CONSTRUCTION OF
PAVED
SIDEWALK/ DRIVEWAY

Driveway Review Form

51 Norman St

Driveway Review

Sketch

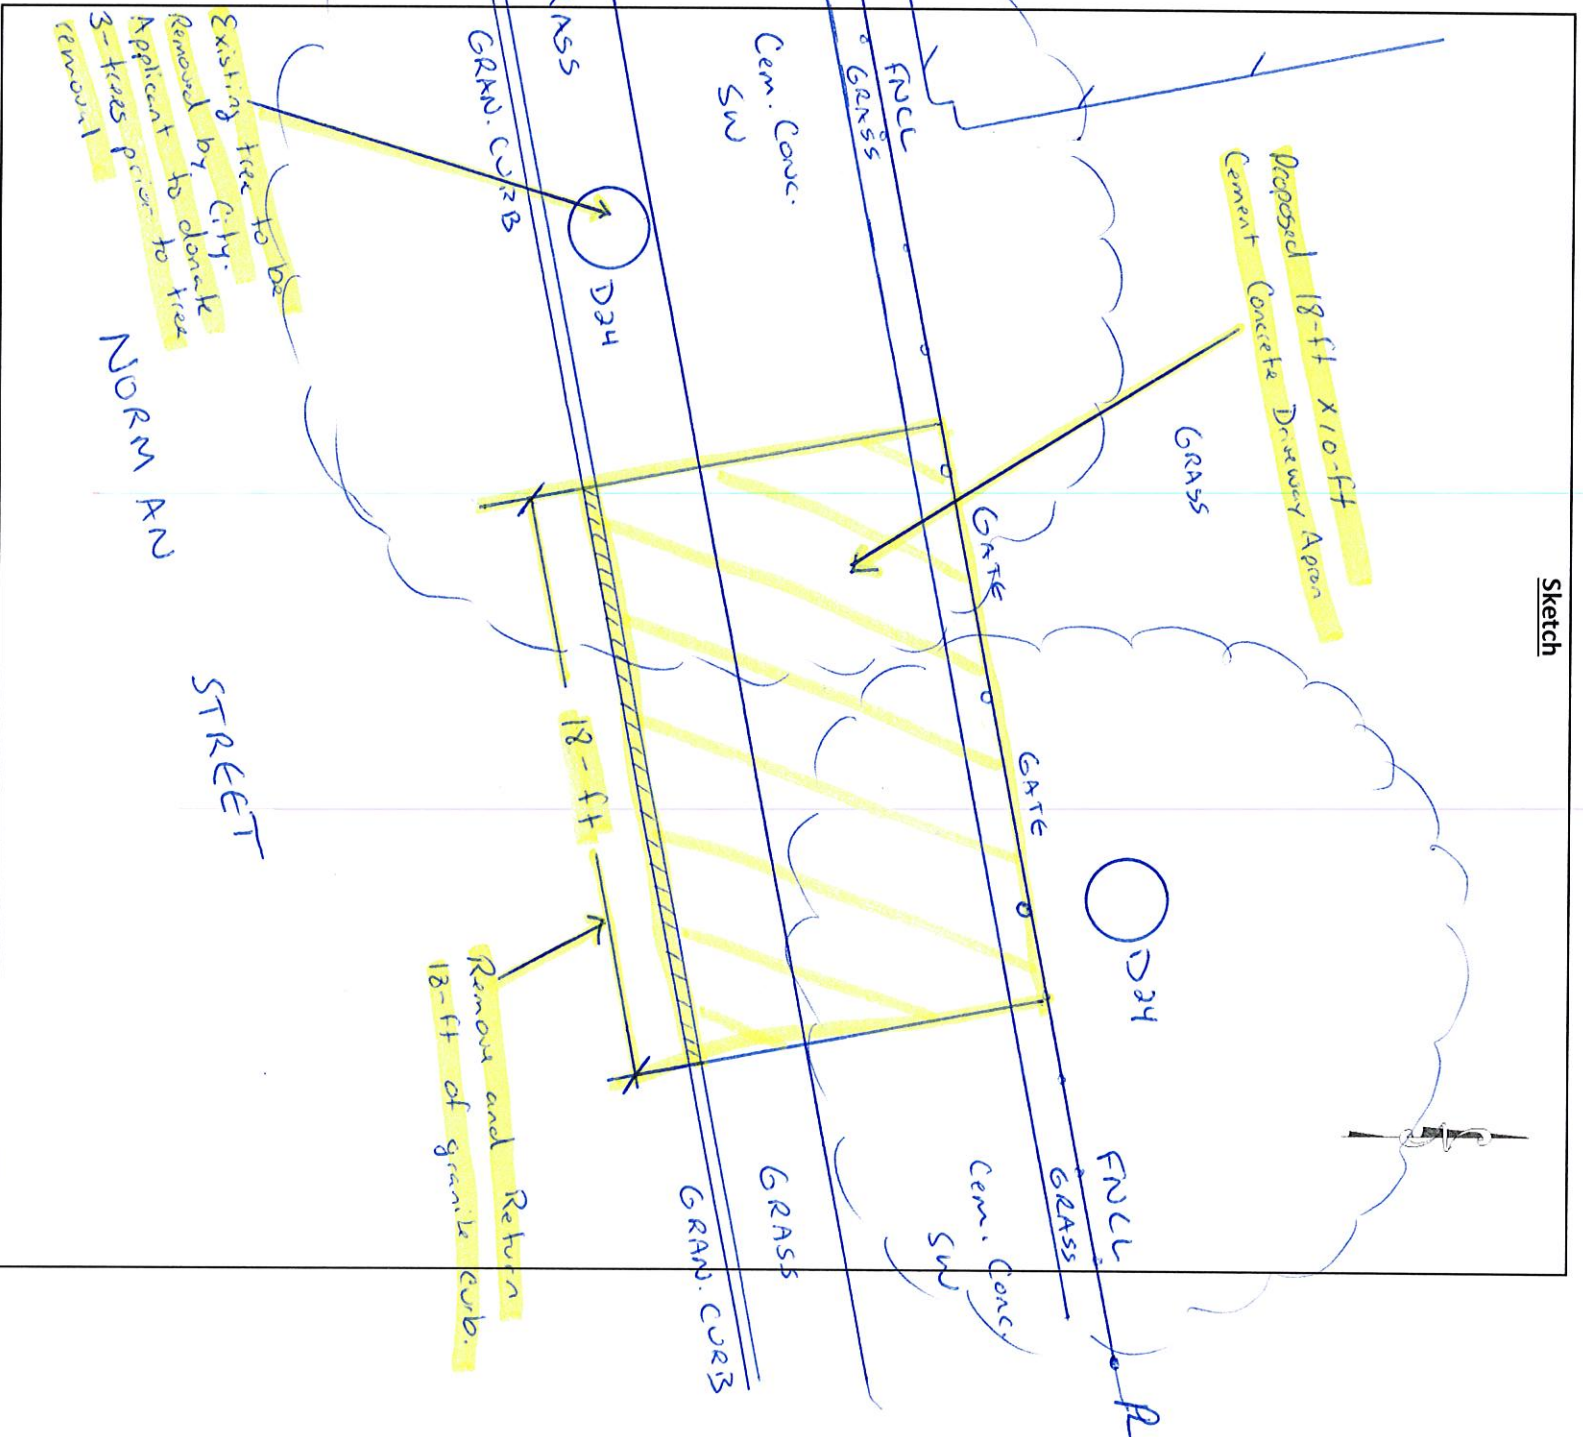
Additional Inspection Notes: 1. Must donate 3-trees for the removal of the existing healthy

City owned tree. 2. Curb return above. 3. Remove 18-ftx10-ft cem.conc.SW and gras ribbon

area. 3.Install new 18-ftx10-ft cem.conc.DW apron in accordance with the most current DPI

Specs. **Note: Contact DPI Repair Office for tree donation information and to schedule the removal of existing tree.
